MAINE TURNPIKE AUTHORITY

ADDENDUM NO. 1

CONTRACT 2016.01

PAVEMENT REHABILITATION

SHEET NUMBER: P-1
CONTRACT: 2016.01
5 of 77

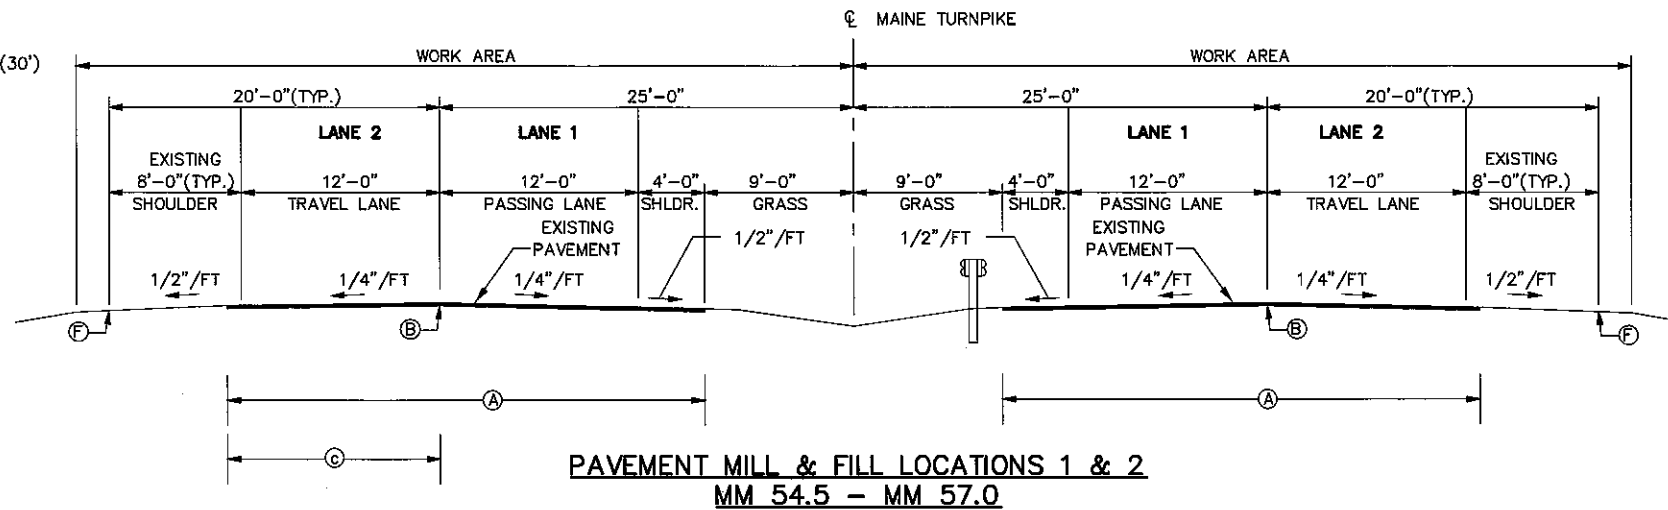
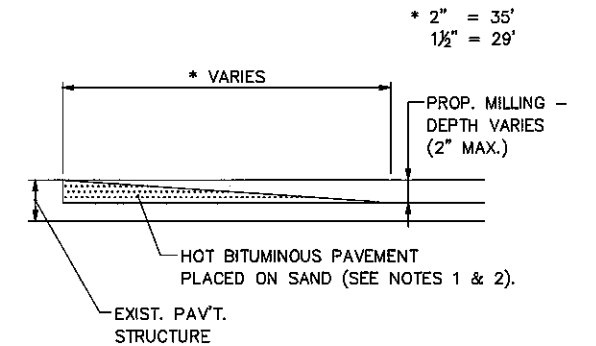
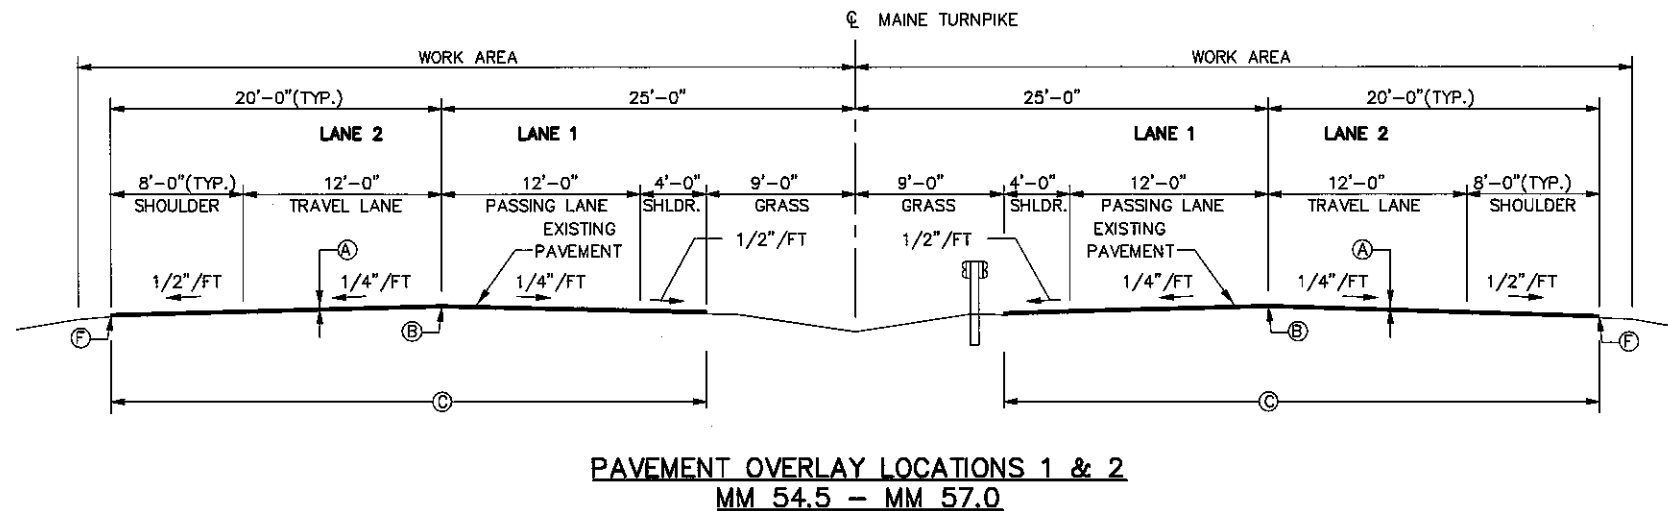
The bituminous concrete pavement shall be milled two inches deep by fourteen feet wide in Lane 2 southbound from approximate station 2770+35 to approximate station 2726+50. The marking of the layout shall be as approved by the Resident.

After the two inch mill, the pavement shall receive a ½” shim.

The GlasGrid8502 interlayer shall be placed on the shim 9’-9” wide centered in Lane 2 followed by the 1 ½” HMA on the same day that this proposed work occurs in this location.

SHEET NUMBER: P-5
CONTRACT: 2016.01
9 of 77

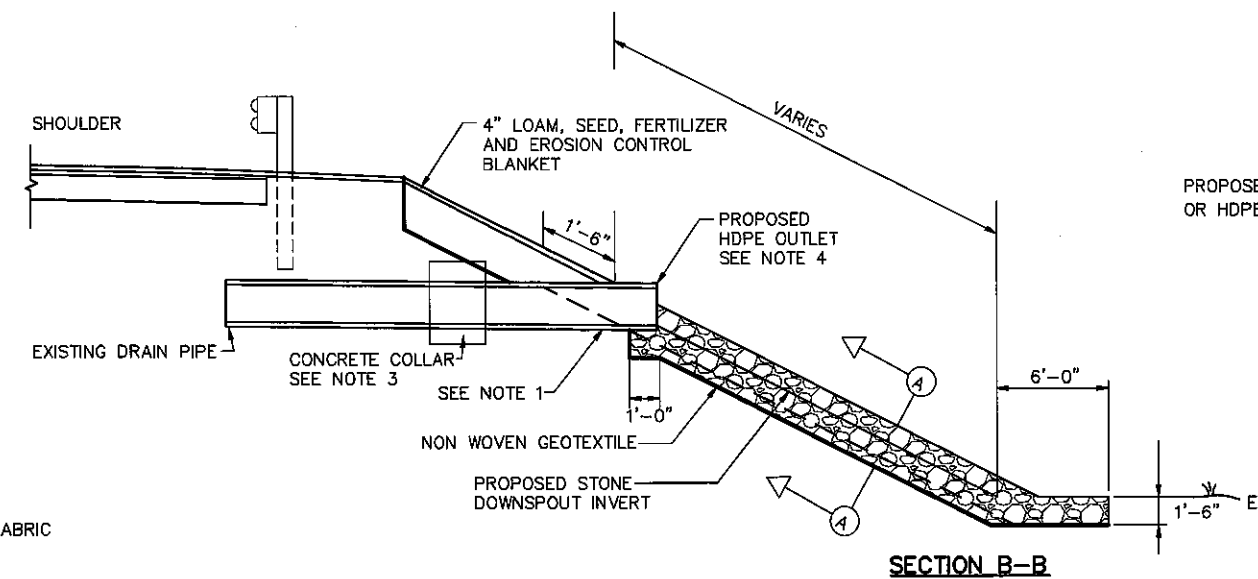
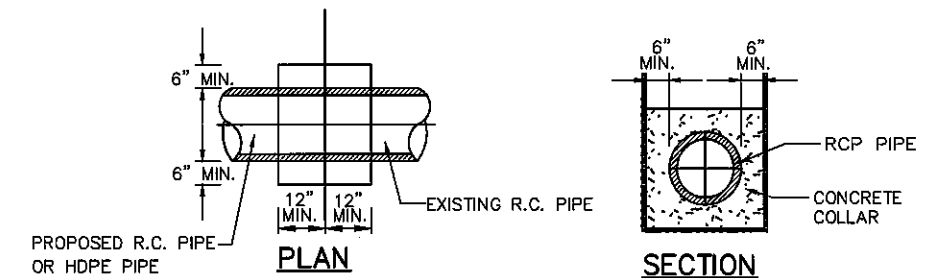
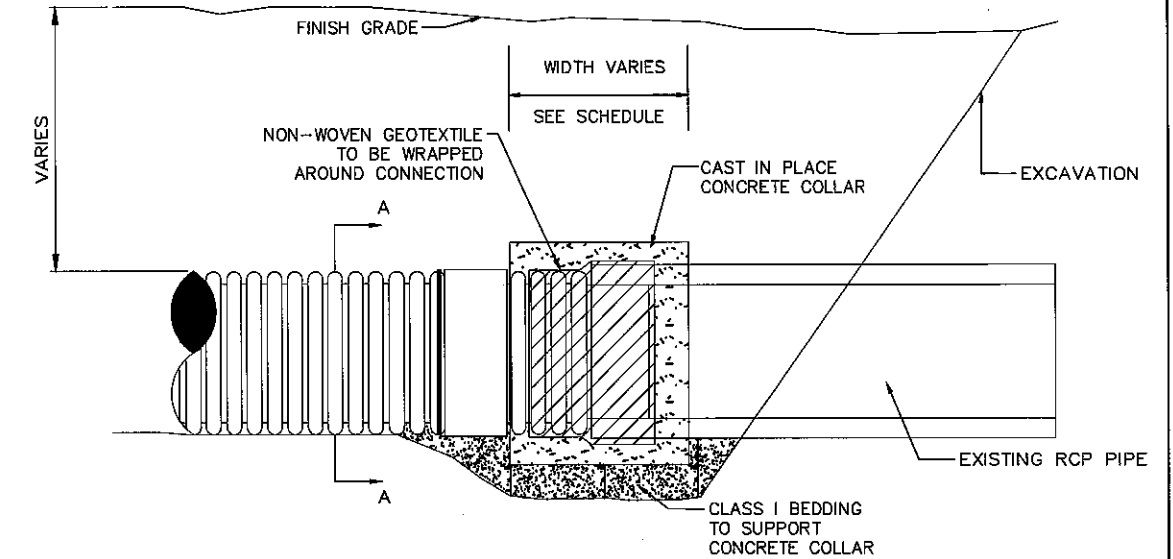
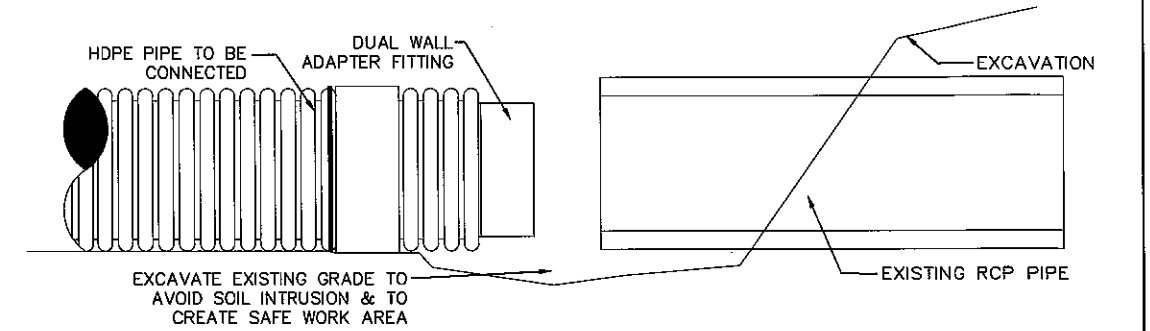
| No. | Revision | By | Date |
|-----|-------------------------------------|-----|------|
| 1 | Shoulder catchbasin detail addition | BAT | 2/10 |
